## **JACOBSEN SUBDIVISION**

**DESIGN EXCEPTION**

Re: Design Exception 24-06 – 738 26 Road (Jacobsen Subdivision)

## DESIGN EXCEPTION 24-06

JACOBSEN SUBDIVISION  
 DESIGN EXCEPTION  
 EXHIBIT 2

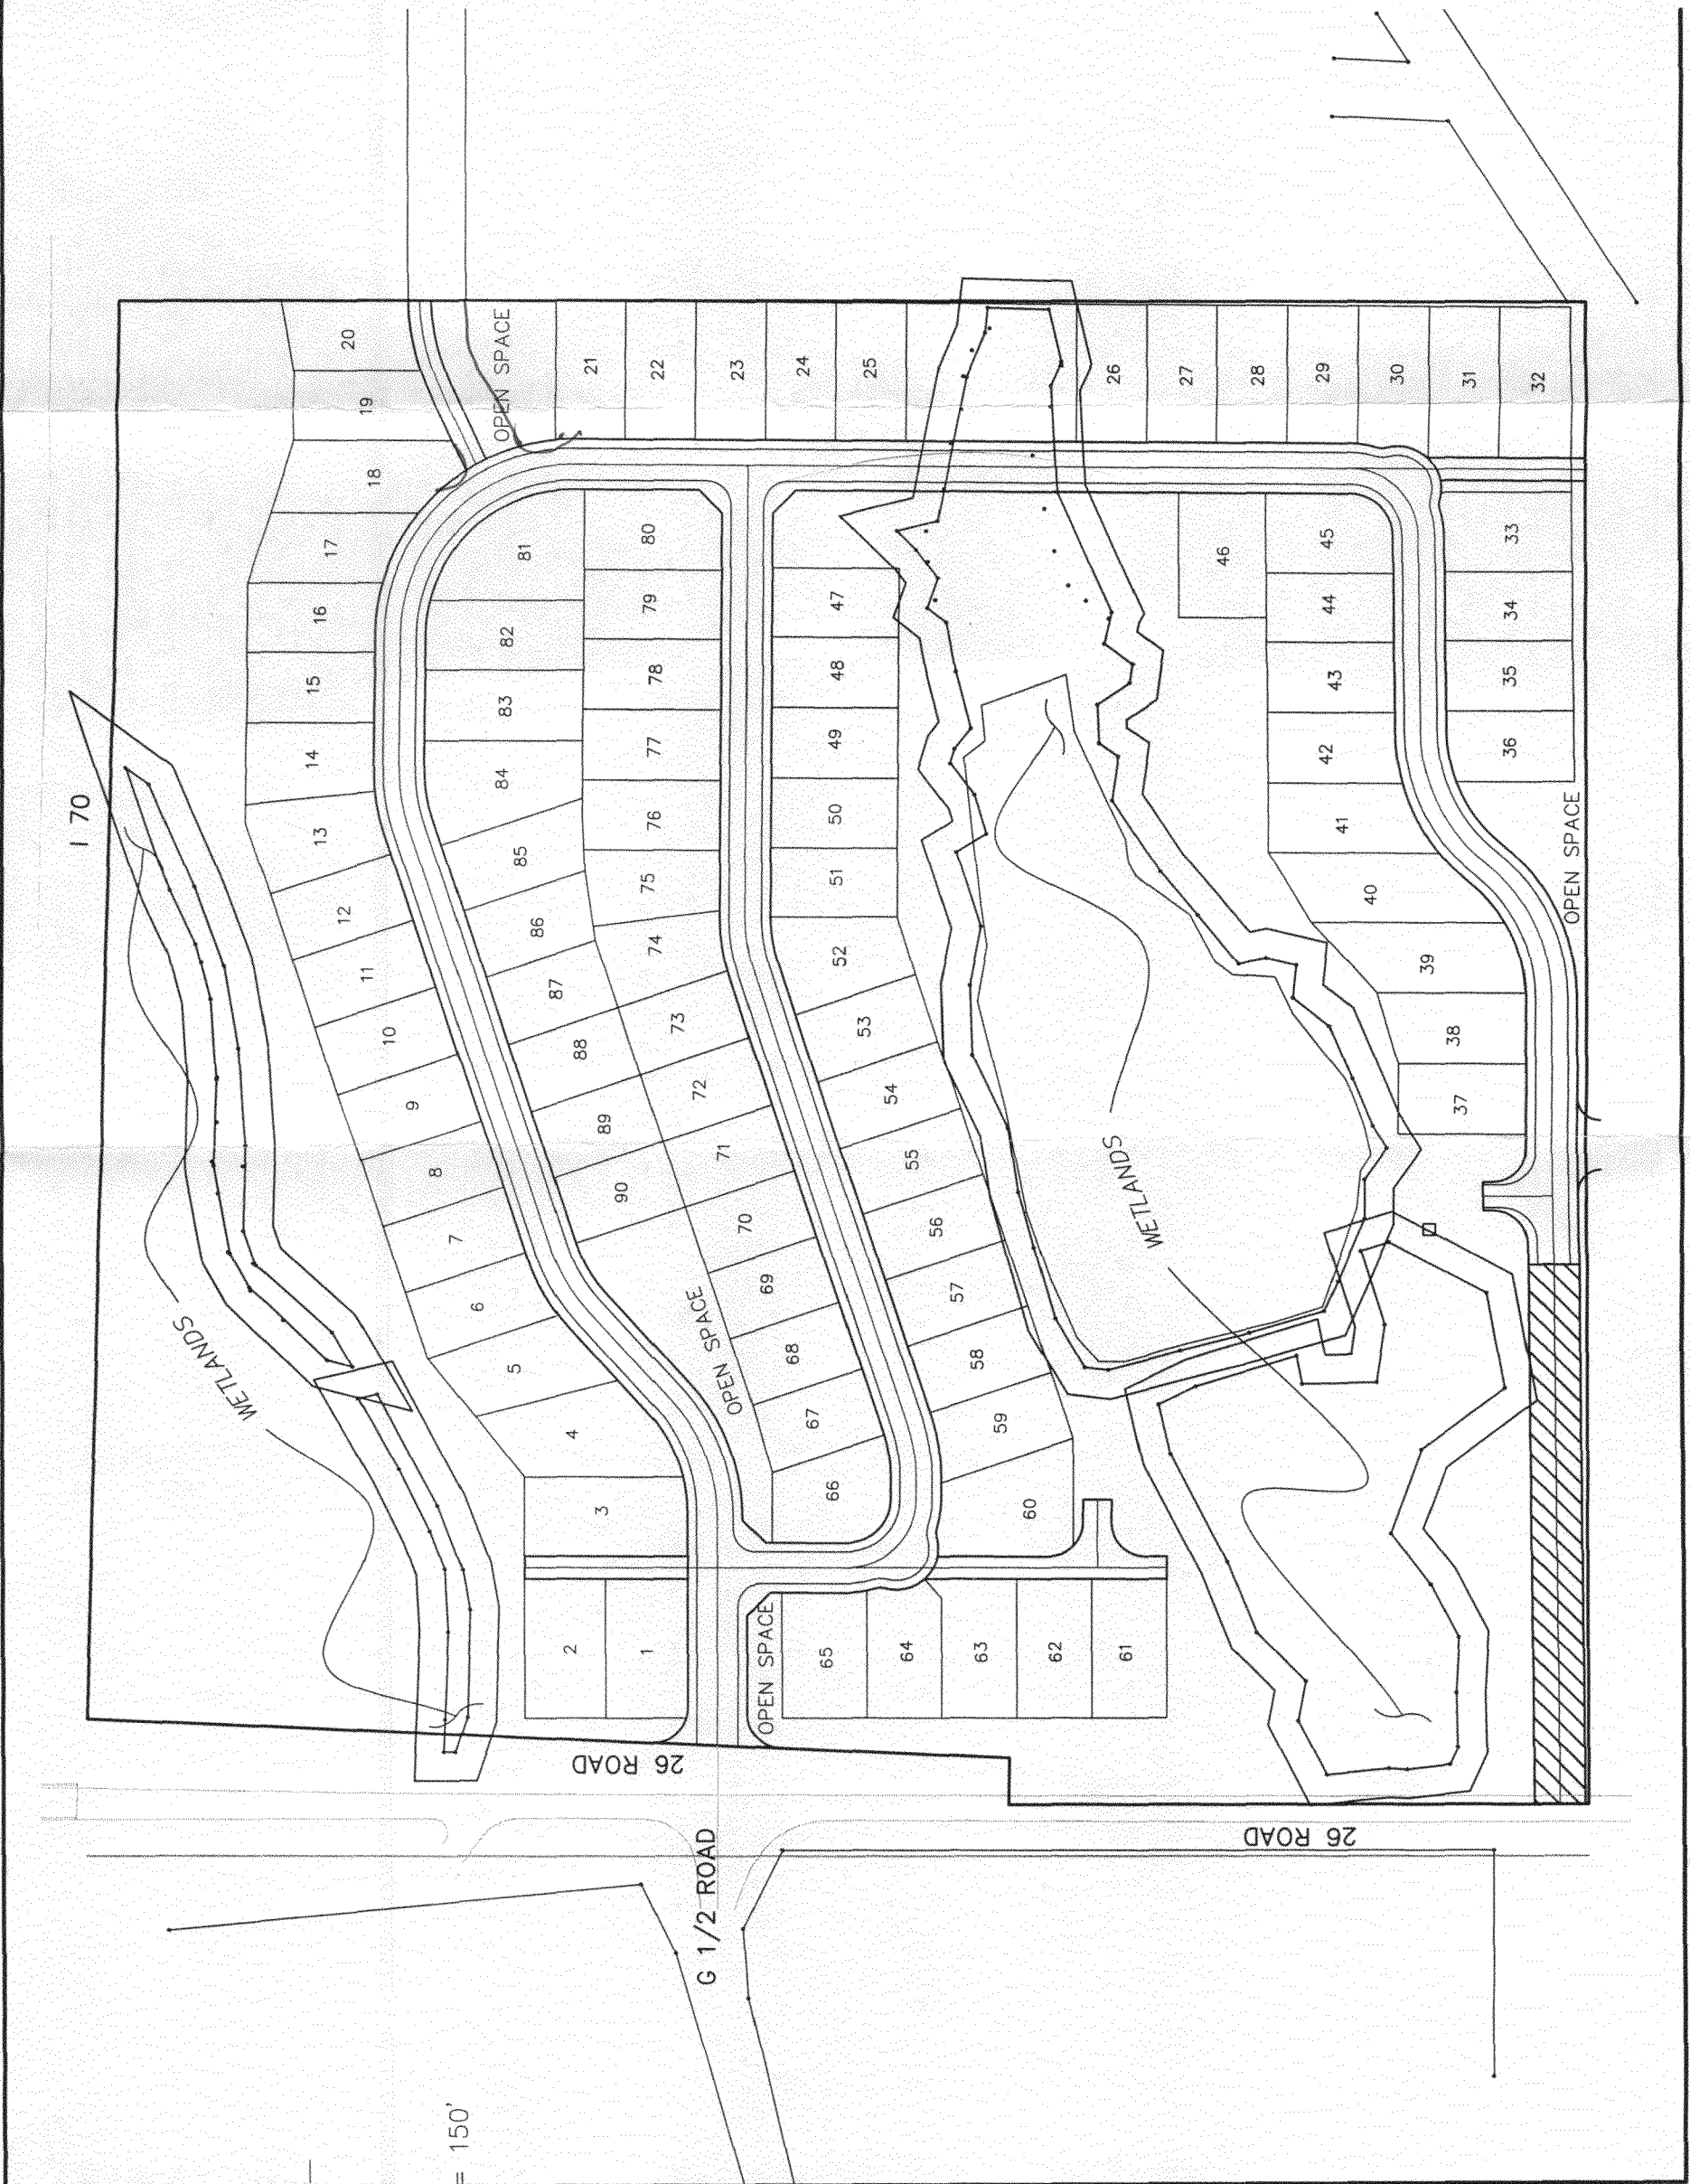
The first design exception request is for a cul-de-sac length longer than limit of 750 feet as outlined in Section 5.1.3 of the TEDS Manual. Exhibit 3 shows the layout of the site with the cul-de-sac length labeled. The 1,290-foot distance is measured from the next full street, which is a 44-foot Urban Residential Street within the subdivision.

First, it is important to point out that the 1,290-foot cul-de-sac length will be temporary. The last 230 feet of the cul-de-sac, as shown on Exhibit 2, is aligned along the adjacent property. This will allow for a future street connection to the property south of the site and will shorten the cul-de-sac length to less than 230-feet. The street was aligned along the property line to create an efficient site layout, but also to provide flexibility for the future street connection to the south.

The applicant's proposed street layout attempts to maximize the use of the existing site, while respecting the topography, wetlands, and the desire to limit accesses onto Collector Streets. The layout requires a cul-de-sac that will be 1290 ft, until such time as the adjacent property to the south develops and creates an intersection near the end of the cul-de-sac.

Staff does not believe safety will be compromised if the parcel interconnectivity requirements are met for adjacent properties to the east and south.

Yes. It is possible to simply extend the cul-de-sac and create another access on 26 Road. This would probably meet most or all TEDS requirements, but due to the topography, sight distance may be difficult to attain without reconstructing 26 Road.

The TEDS Committee approved the exception request for a cul-de-sac length of approximately 1290' with the understanding that the applicant will construct two public roadway stubs (per city standards) to the parcel to the south; one at the location shown near the proposed hammerhead and one near the south east corner of the site adjacent to lots 31, 32 & 33. The Committee also stressed the importance of a public roadway connection to the east at Cottonwood Drive.

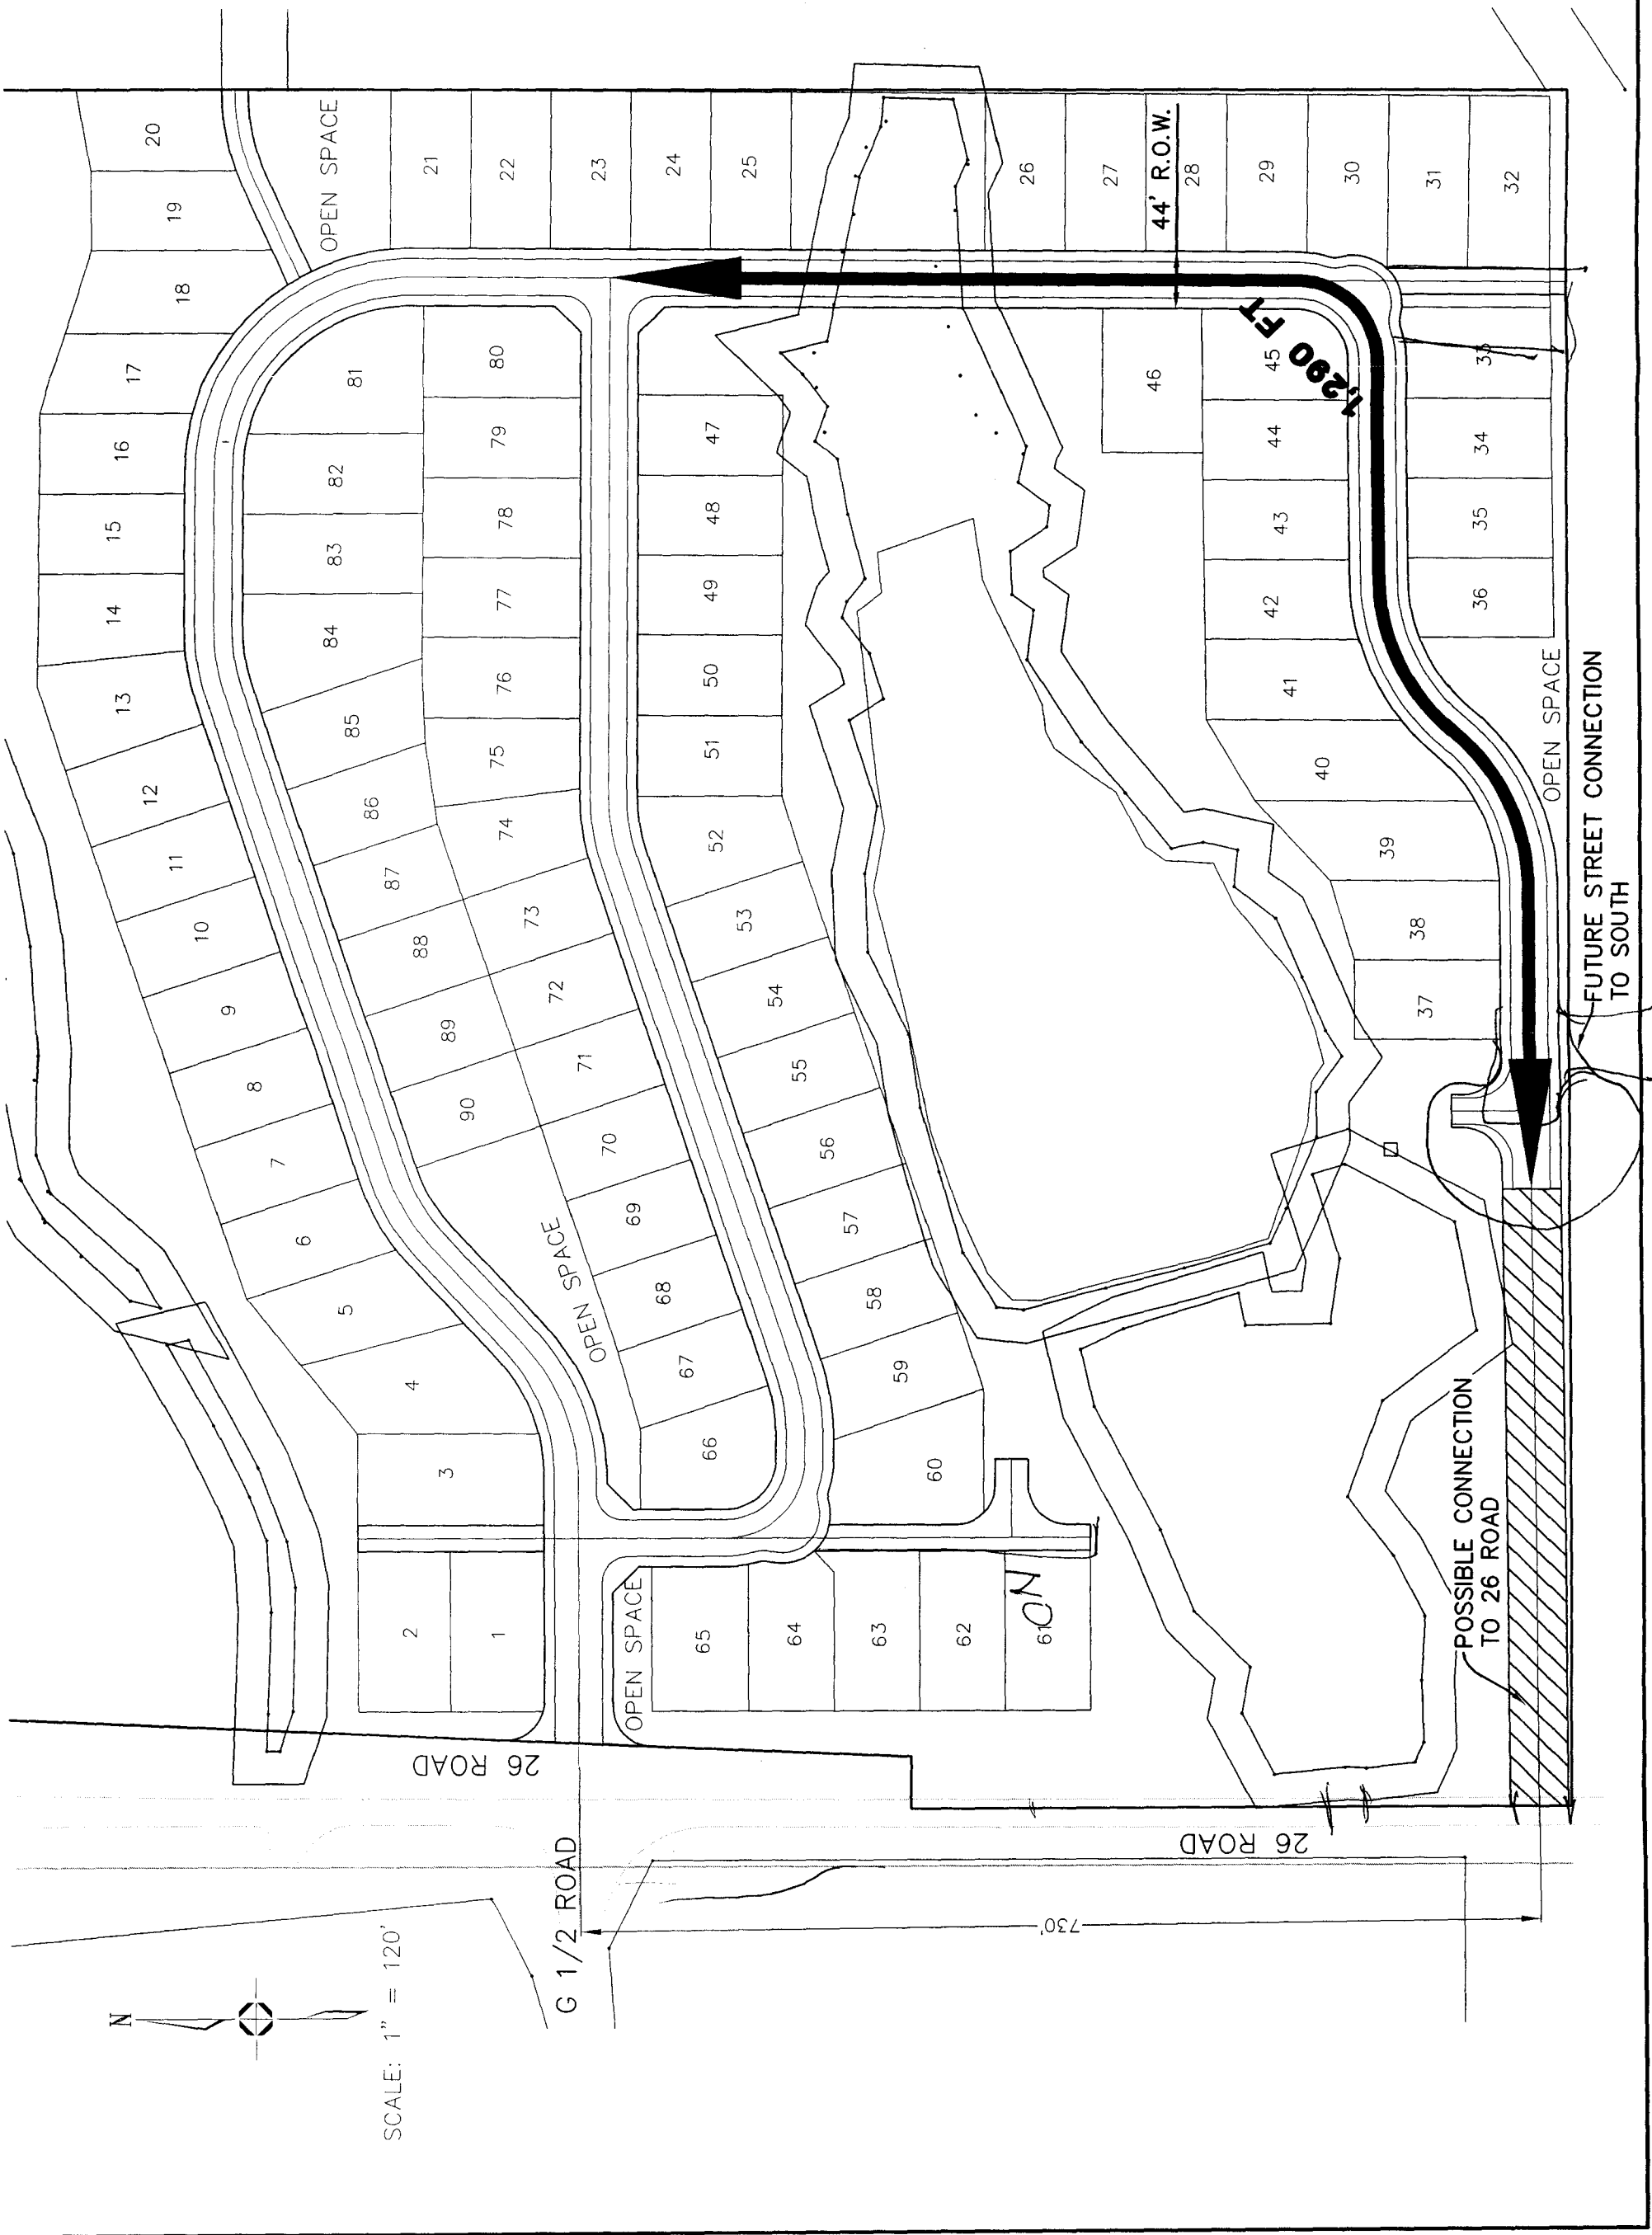
The current site plan for the project shows a shared driveway along the western boundary of the site, just south of the main entrance serving lots 61–63, and possibly lot 60. The shared driveway as proposed will meet all twelve guidelines as outlined in Section 13.2.1 of the TEDS Manual for shared driveways, except guideline number 3. Guideline number 3 states that shared driveway can be a maximum of 150 feet long. The shared driveway shown is approximately 205 feet as measured from the street right-of-way. Please see Exhibit 6 for more detail.

The applicant proposes to construct a shared driveway that is greater in length than the maximum allowed distance of 150 feet.

Emergency services access may be compromised.

Yes. A typical public cul-de-sac could be constructed. Also, it may be possible to modify the existing lot layout slightly to accommodate a 150' shared driveway without a hammerhead that would serve the proposed four lots.

Staff recommends denial of the requested exception, unless it can be shown that small modifications to the lot layout can accommodate a 150' shared driveway.

The TEDS Committee approved this request as proposed.

# Cul-de-sac Length - Exhibit 4

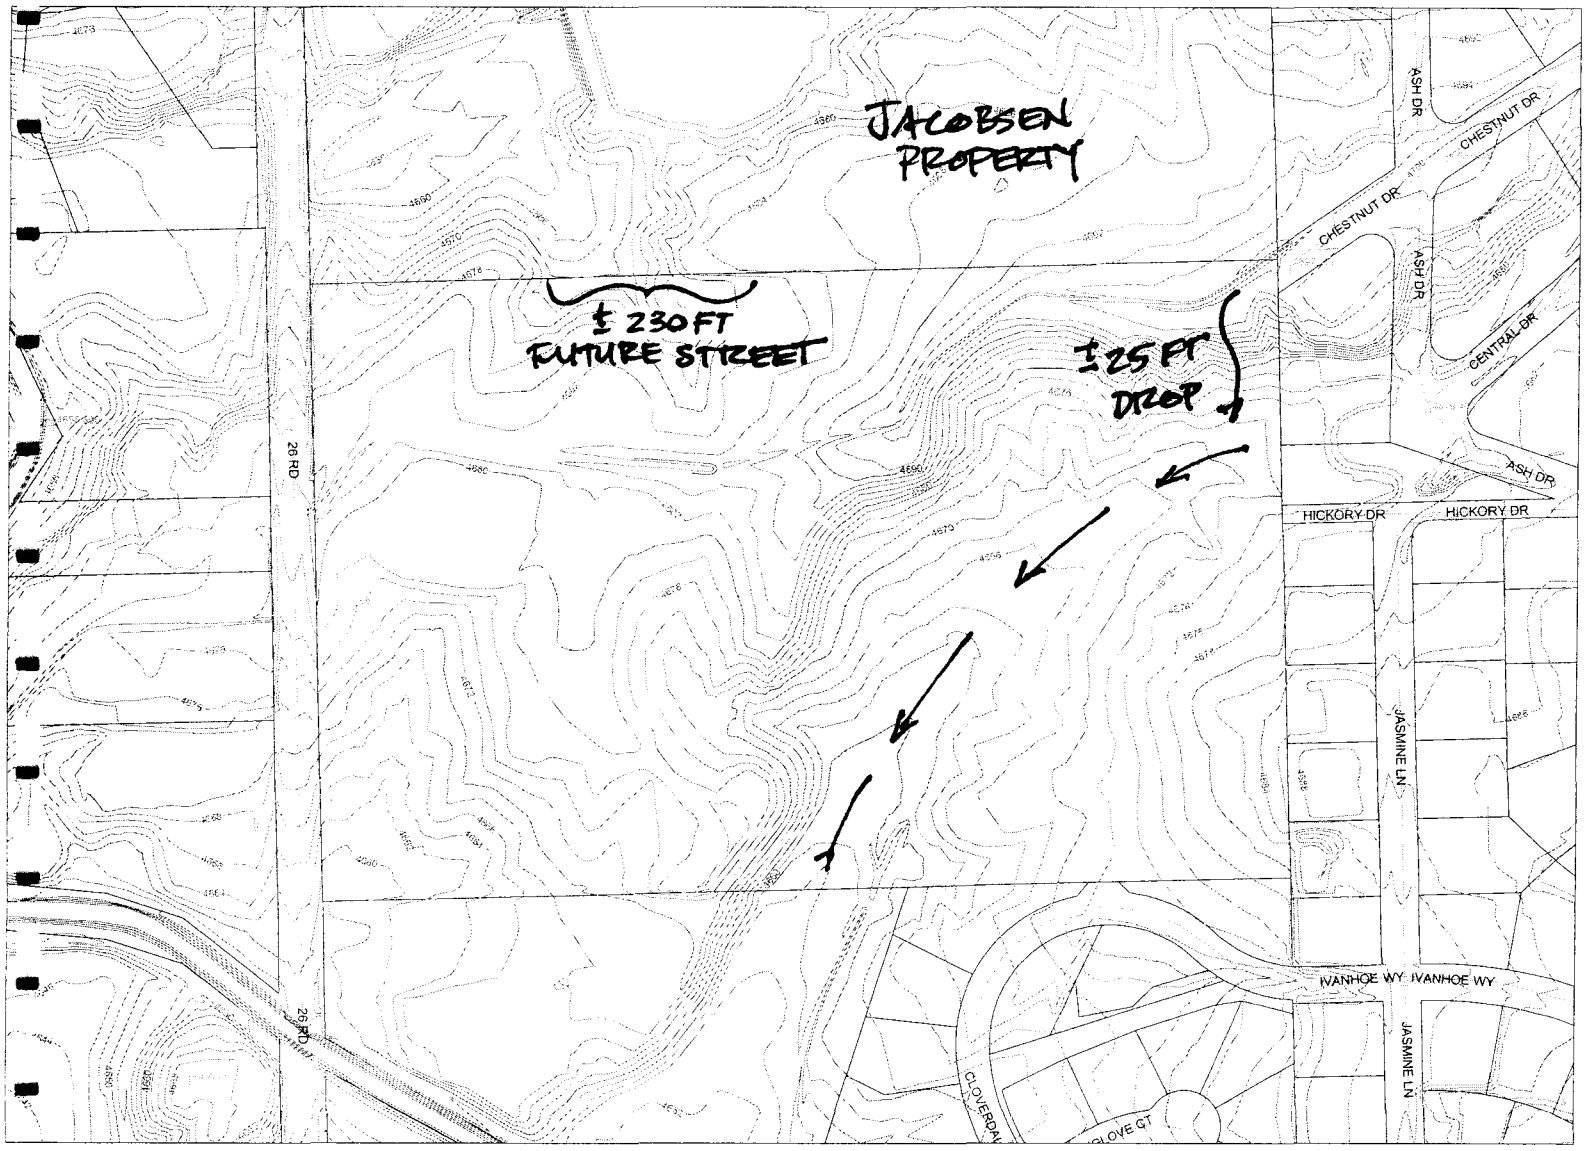
In addition, the topography further to the east along the southern boundary of the property drops approximately 25 feet into a historic drainage channel. Please see Exhibit 4. This would significantly limit the possibility of a future street connection.
